SERVICE BULLETIN

AFTER BURNER STD

Trigger does not shoot rapid fire (Only 1 shoot)

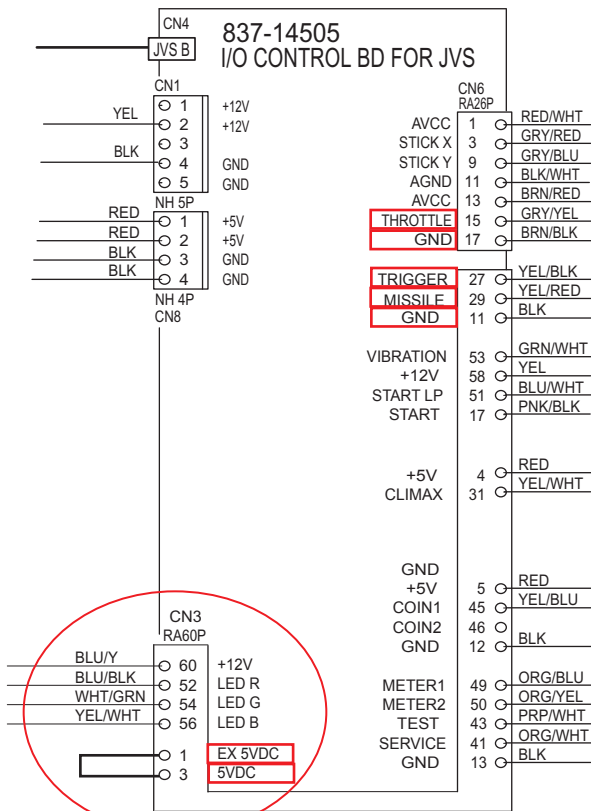
Please check wiring on the I/O CONTROL BD

THROTTLE ----- PIN 15 on the CN6 connector
(Cable color is Gray/Yellow)

★ GND ----- PIN 16 on the CN6 connector
(Cable color is Brown/Black)

★ TRIGGER ----- PIN 27 on the CN3 connector
(Cable color is Yellow/Black)

MISSILE ----- PIN 29 on the CN3 connector
(Cable color is Yellow/Red)

GND ----- PIN 11 on the CN3 connector
(Cable color is Black)
